NABI: WMATA – Duraflex Exhaust Connector Installation

Property and TopBus Number:
WMATA 325000 & 325500 – 8001 thru 8105.

Issue: Vibol Exhaust Connector

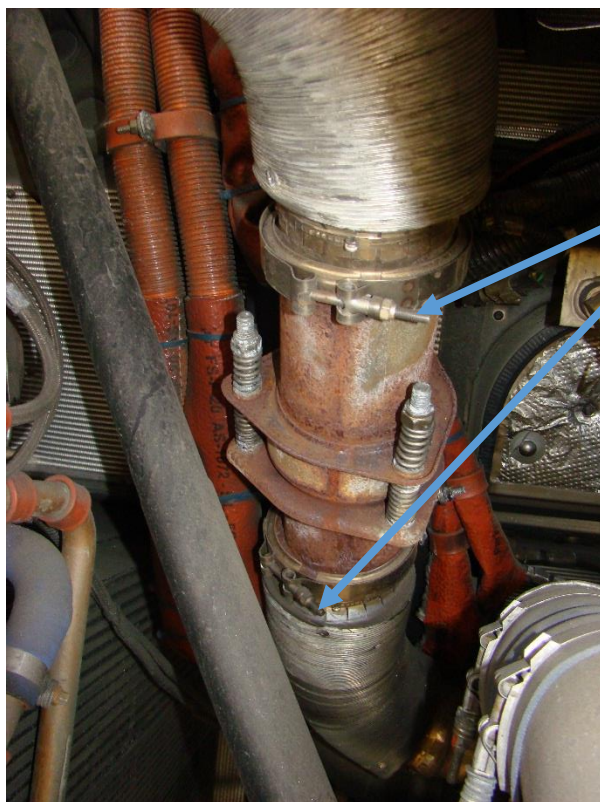
Reason/ cause: Vibol exhaust connector is too rigid

Solution: Replace existing Vibol connector with Duraflex connector

Item	Description	PN	Qty
01	Duraflex 4" OD x 10" Length	500-1408-080	1
02	4 1/2" ID V-Band Clamp	511-1408-003	1
03	Gasket	10C-1408-016	2
04	Clamp, Exhaust, V-Band Clamp	0111613	AR
05	PIPE, EXH, TURBO, BRT	42H-1408-001	AR
06	Exhaust Blanket	634-8111	1

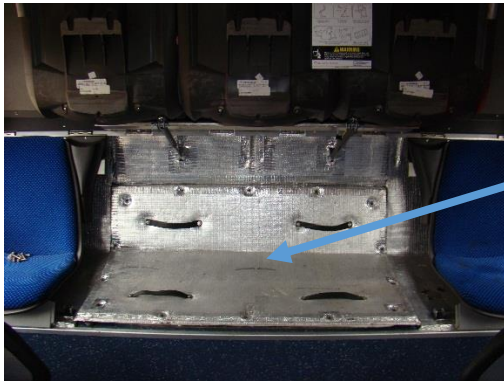
7. Remove the bolts fastening the engine access cover (see below) & remove cover from the work area.
